SUBJECT: Request for Additional Information - Copperwood Mine - Mining Permit Application Amendment Request March 2018 - MP 01 2012

The Michigan Department of Environmental Quality (MDEQ) has conducted an initial review of the Copperwood Mine Mining Permit Application Amendment Request (Application), March 2018, MP 01 2012. To assist in the completion of the review, please respond by addressing the following items of request for additional information to supplement, clarify, and support the proposed amendment:

Figure 1: Main Access Road Cross Section

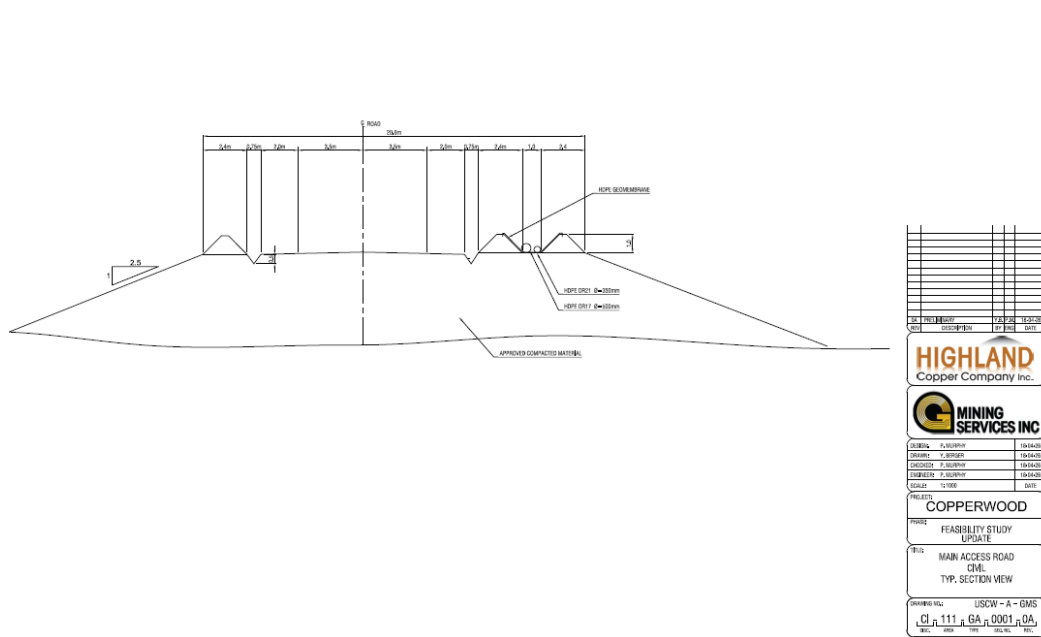
- 2. Explain how tailings will be transported to the Tailings Disposal Facility (TDS) in the proposed site layout, and include a figure showing the location of the tailings transport system.**

The transport of tailings slurry to the TDF and reclaim water from the TDF to the process plant uses pipelines which will follow the main access road. The cross section in Figure 1 below shows the designated space for pipes on the main access road.

Both the slurry and reclaim pipes will be HDPE pipes. The pipes will have a berm on either side of the pipelines with a geomembrane liner on the interior of the berms and underneath the pipelines. The system will naturally drain to the site event pond located next to the process plant.

Figure 2: Contact Water Management for the Copperwood Mine

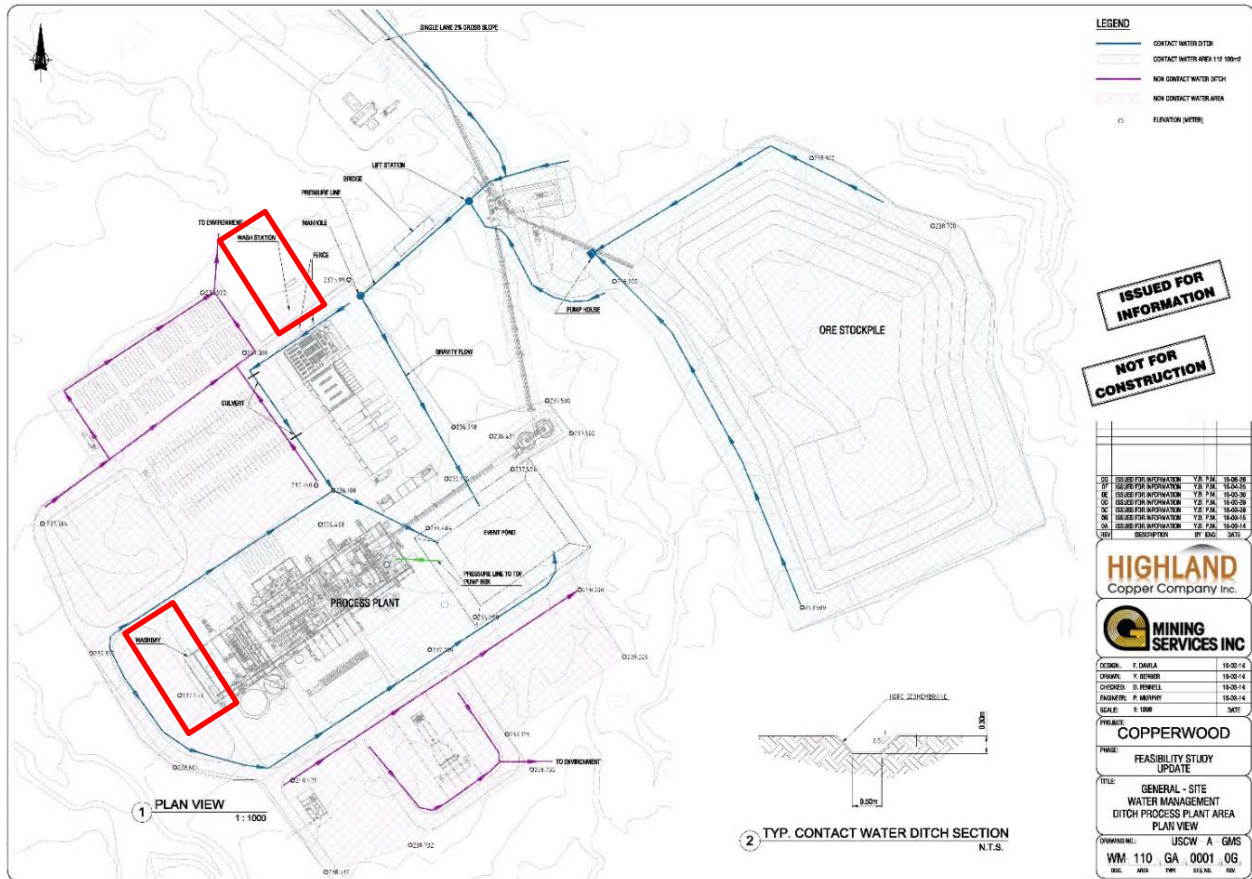
- 6. MP 01 2012 Special Permit Condition G1 requires that all vehicles and equipment leaving the contact area of the main facilities site will be required to be washed before leaving, and wash water shall be used as facility process water, routed to the tailings**

As Figure 2 below shows, there will be two stations for truck washing located at the concentrate loadout and upon entry to the parking lot from the box cut and ore stockpile roadway. The colors as shown on the figure correspond to non-contact and contact water. All water shown as contact water will either have gravity fed ditches directly flowing or being pumped to the event pond shown. The event pond has a pipeline that conveys water into the TDF pump box and then to the TDF for storage and eventual treatment at the water treatment plant. All non-contact water will be routed to discharge into Unnamed

Creek located between the process plant and the ore stockpile / box cut areas.
